26' GROWING DOME DOORWAY GLAZING MODIFICATIONS Using Twin Wall Polycarbonate

DOORWAY MODIFICATIONS

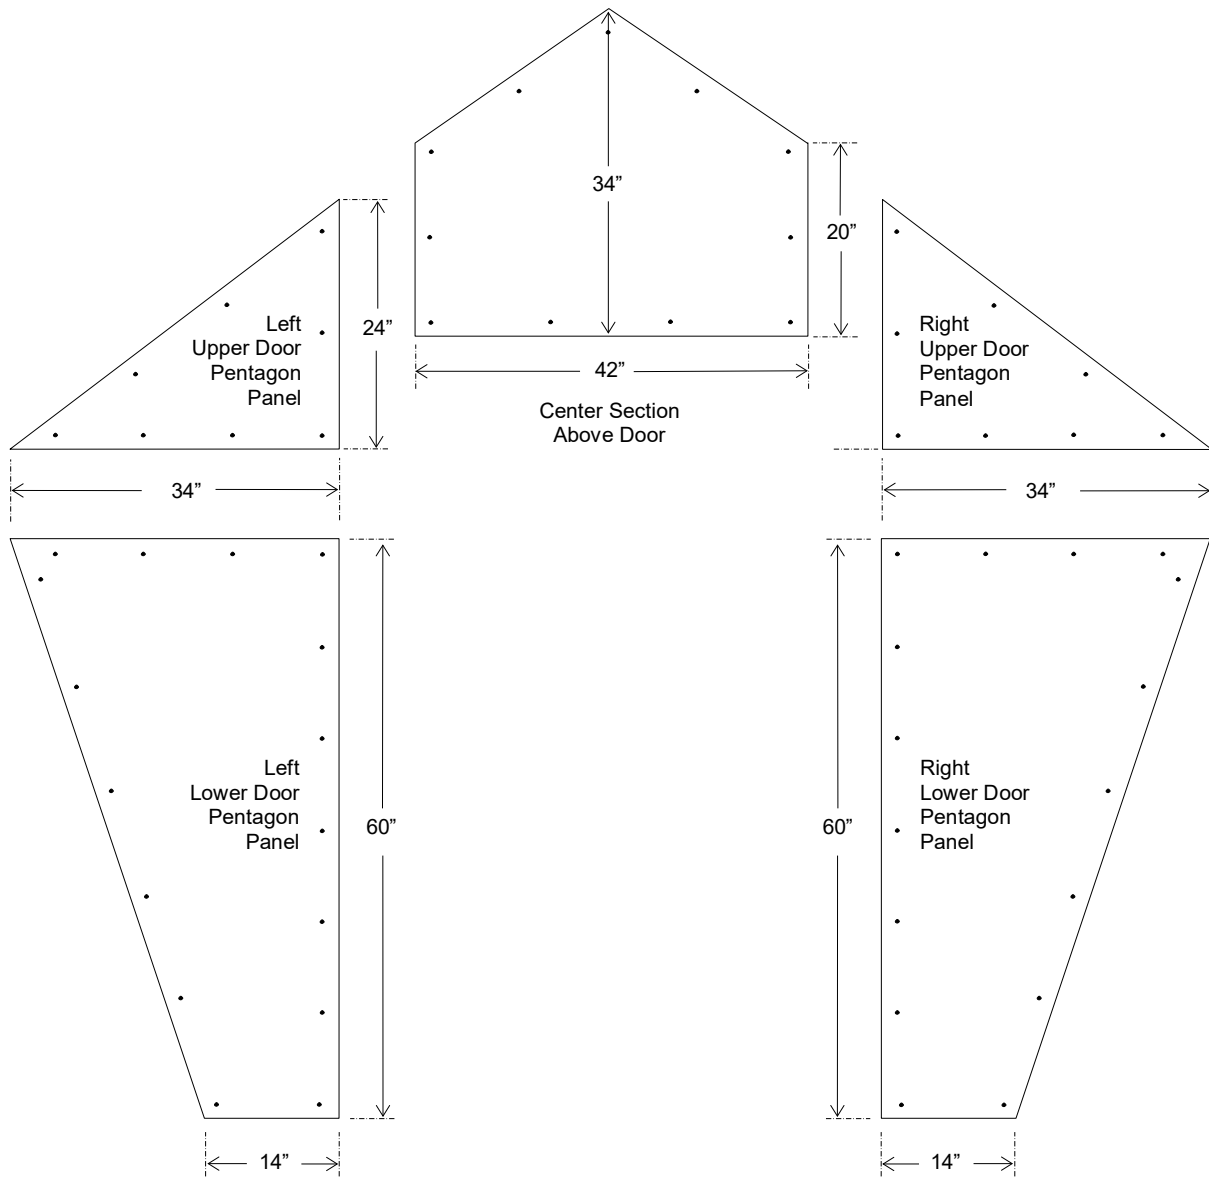
Due to the lack of availability of large glazing pieces, when building an 18' dome with twin wall glazing, some modifications need to be to the doorway glazing. Instead of 4 pieces (Upper and Lower Pentagons), there will be 5 pieces as shown below. The doorway glazing is cut to the sizes shown which is larger than required. It is trimmed on site for an exact fit.

NOTE: The bottom edge of the lower door pentagon panels that attach to the top of the foundation wall (see paper dome model) get bottom caps that require longer screws. Using the 2" bottom cap screws provided, screw through the bottom caps, glazing panels, horizontal metal trim, and into the wood struts, following the same screw pattern. These are not installed, however, until Step 12.
